### REMARKS

This application has been reviewed in light of the Office Action dated March 18, 2003. Claims 17-22 are pending in this application, with Claims 17, 20, and 22 in independent form. The original Claims 1-16 have been cancelled, without prejudice or disclaimer of the subject matter presented therein, and have been replaced with newly added Claims 17-22 to more clearly define Applicant's invention. Favorable reconsideration is requested.

FIG.3

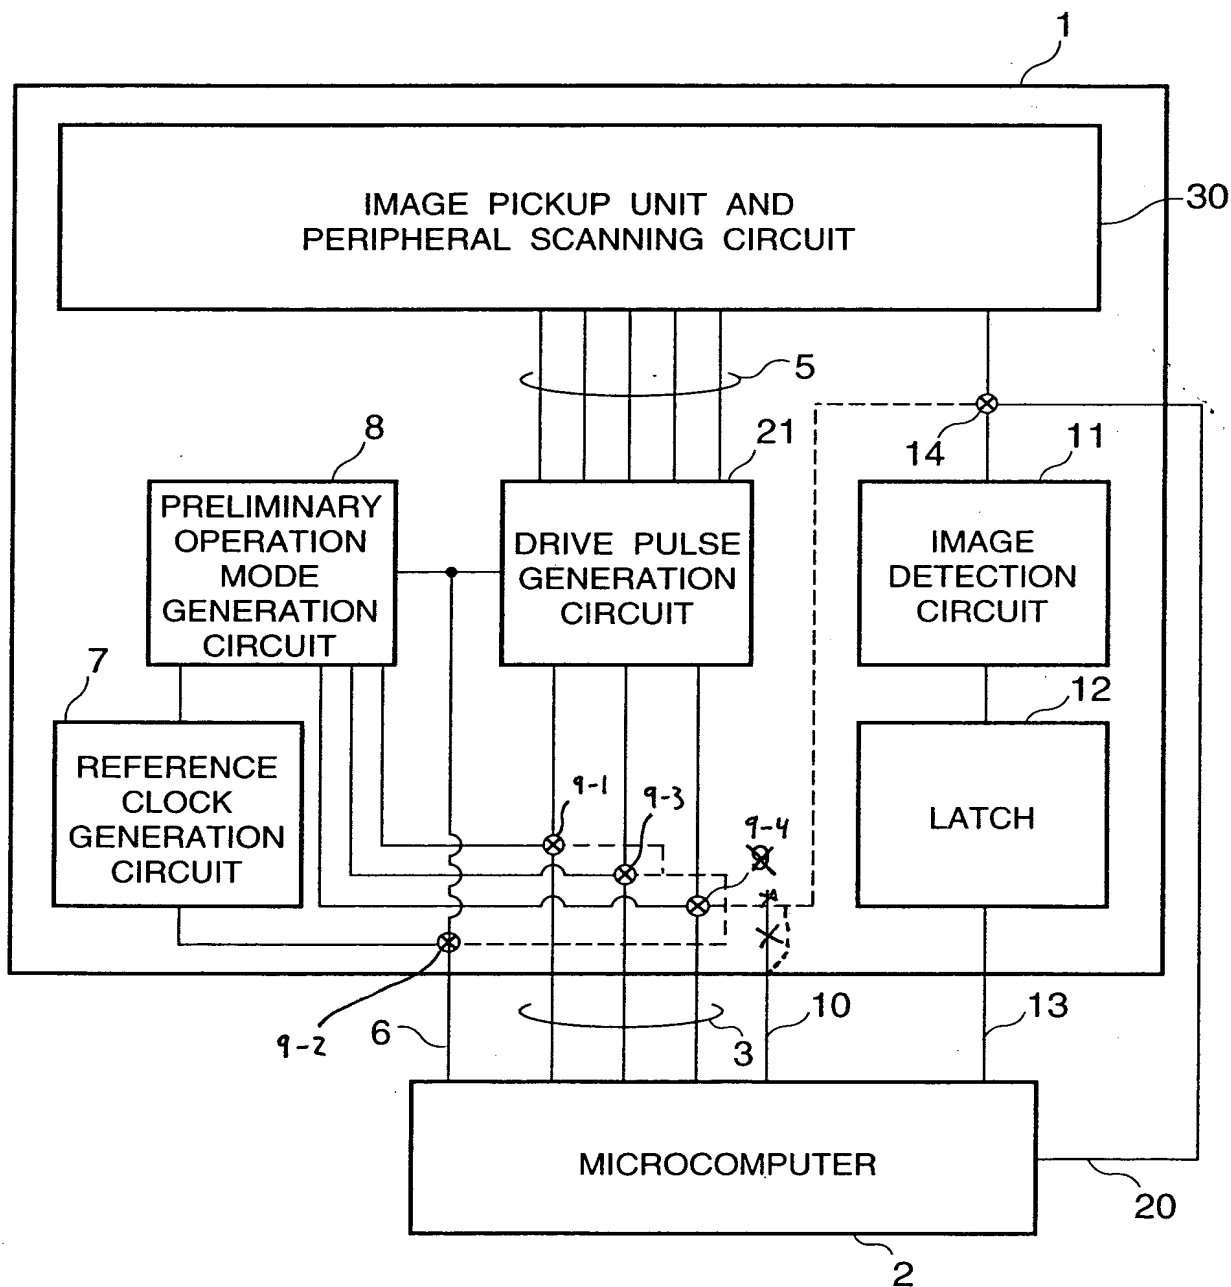
The Office Action includes several objections to the drawings. In particular, Figures 3 and 4 were objected to as not adequately demonstrating how output line 10 connects to switches 9 and 14, and Figure 3 was objected to as not including reference numerals 9-1 and 9-2, which are mentioned in the specification. In response, Applicants are amending these figures to include reference numerals 9-1, 9-2, 9-3, and 9-4, instead of reference numeral 9, and to connect output line 10 to the dotted lines connected to the switches 9 (now 9-1 to 9-4) and 14. Please refer to the attached copies of Figures 3 and 4, showing the above-described changes in red. In accordance with the revised amendment format, corrected drawings incorporating these changes are being prepared, and will be submitted as soon as they are complete. Applicant notes that the specification has also been amended to refer to switches 9-1 to 9-4, instead of just 9, 9-1, and 9-2.

By these amendments to the figures and drawings, Applicant submits that the objections to the drawings have been remedied and respectfully requests their withdrawal. Applicant believes that no new matter has been added by these amendments.
